Title: Check For Presence Of Mast Root Drain Hole		
AG-SB-2019-01-A-EN		Compliance Category:
Applicability		A - MANDATORY B - RECOMMENDED C - OPTIONAL
Aircraft type & model: MTO2017	Affected Serial number(s): All MTO2017 models	
The maintenance manual to be referenced is this stated or subsequent issue.		As per AutoGyro website
This form is the response from AutoGyro GmbH either against a problem found in the product in service requiring a containment or rectification action, or as service information for aircraft modification incorporation. For help, contact AutoGyro on 49(0)5121 88056-00, or email airworthiness@auto-gyro.com .

Reason and overview of the Service Bulletin (cause of problem if known)

Fig. 1

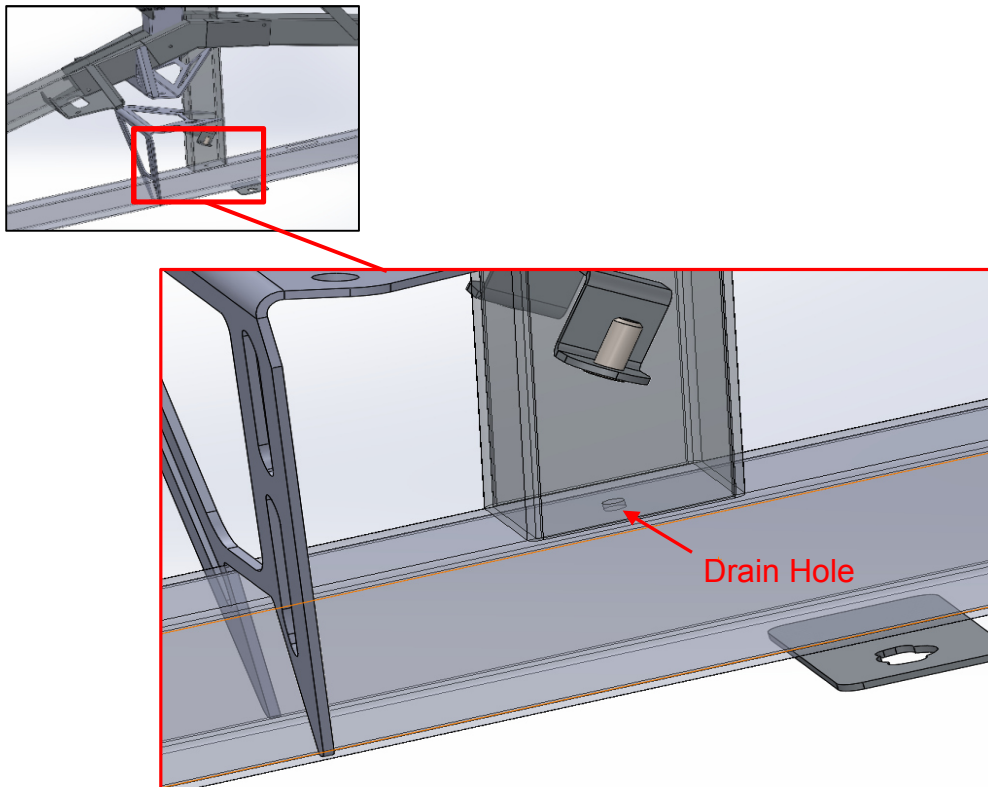
It has been found that during production of the main frame, the main mast root drain hole (fig 1) may have been left out of the frame assembly on a small number of MTO2017 frames currently in the market.

This may lead to flushing fluids used during the electrochemical polishing process remaining trapped in the forward mast tube.

Fig. 4

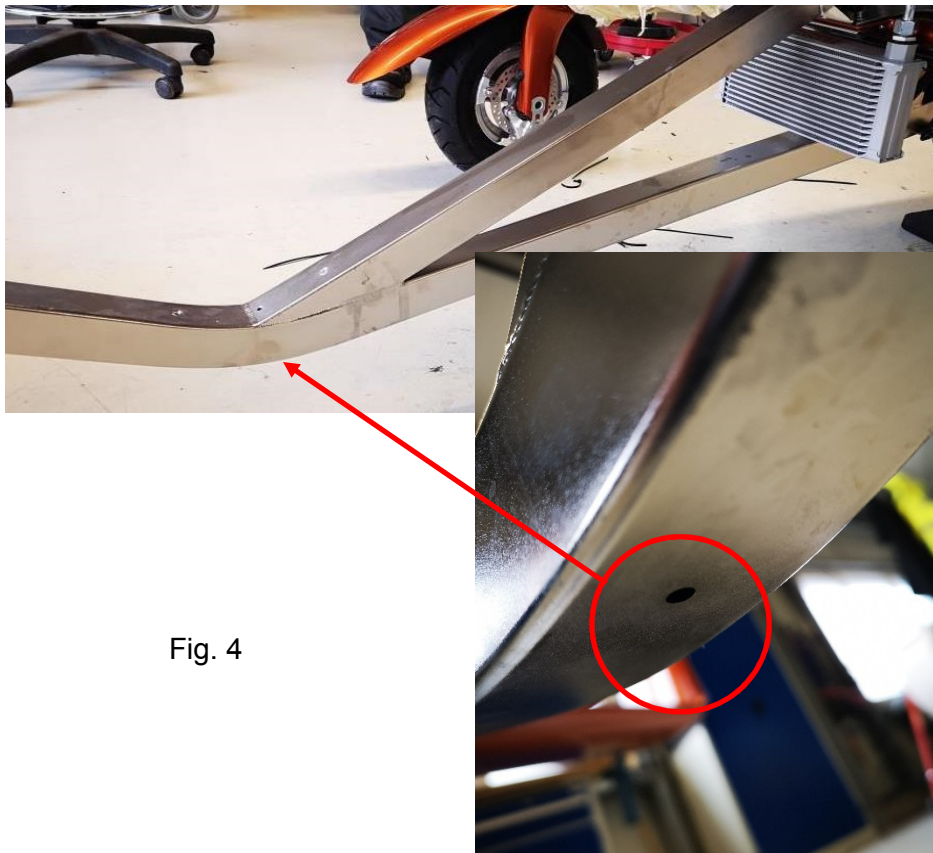
- e. If distilled water is observed emanating from the rear keel tube lower drain hole (fig 4) then the mast drain hole is present. No further action is required. Re-assemble the side & mast fairings.

Fig. 5

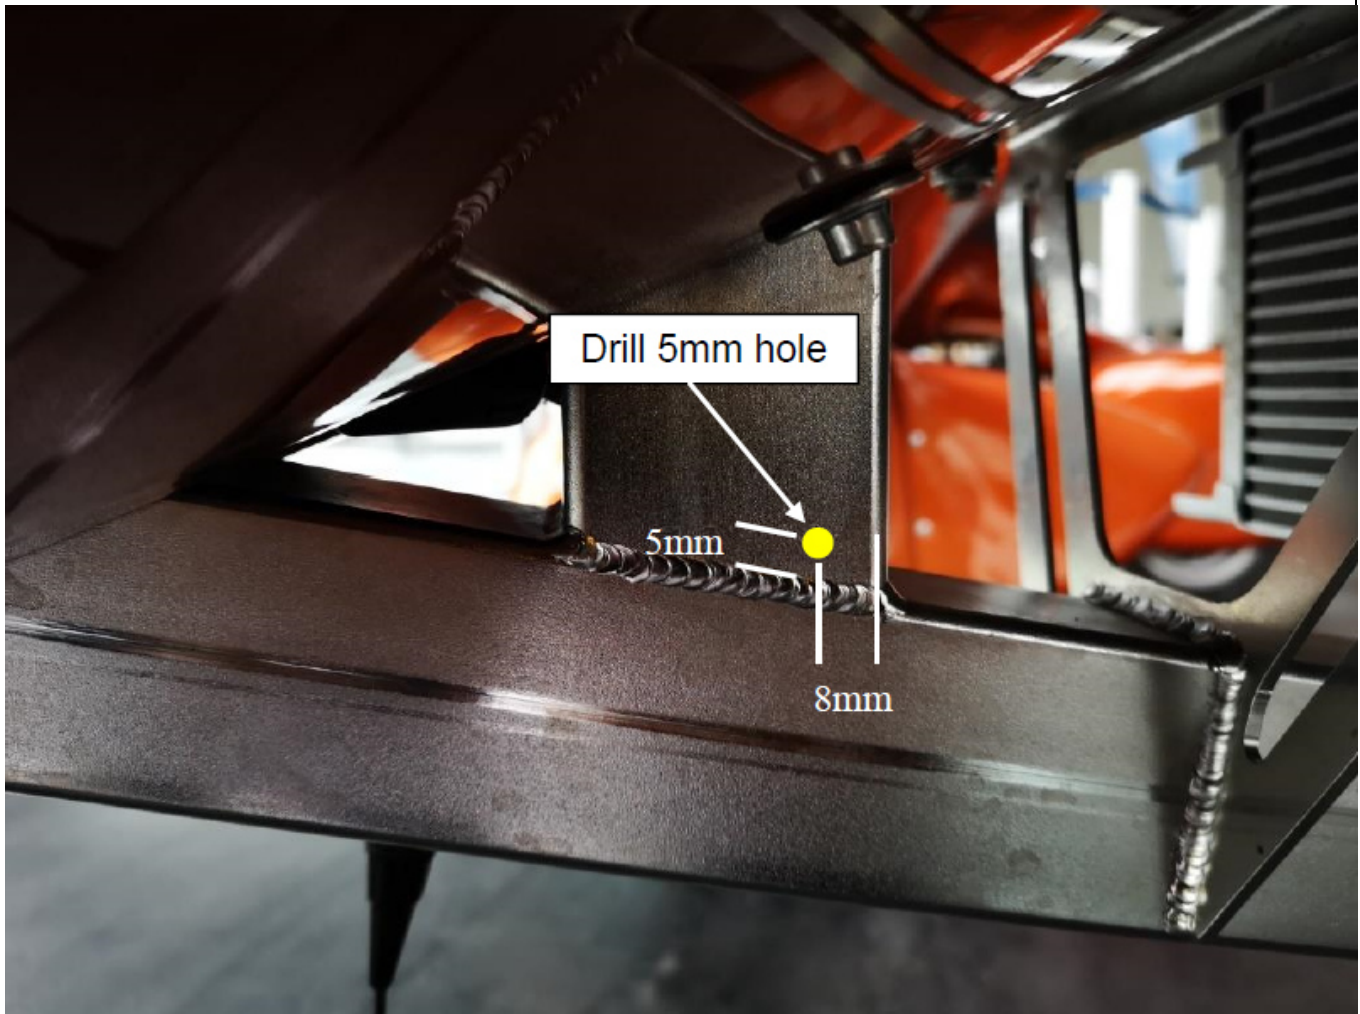
4. Centre-punch, then drill a 5mm hole on the left rear side of the mast root 5mm above the weld, 8mm forward of the rear vertical curved edge (fig 5) and allow any trapped fluid to fully drain.
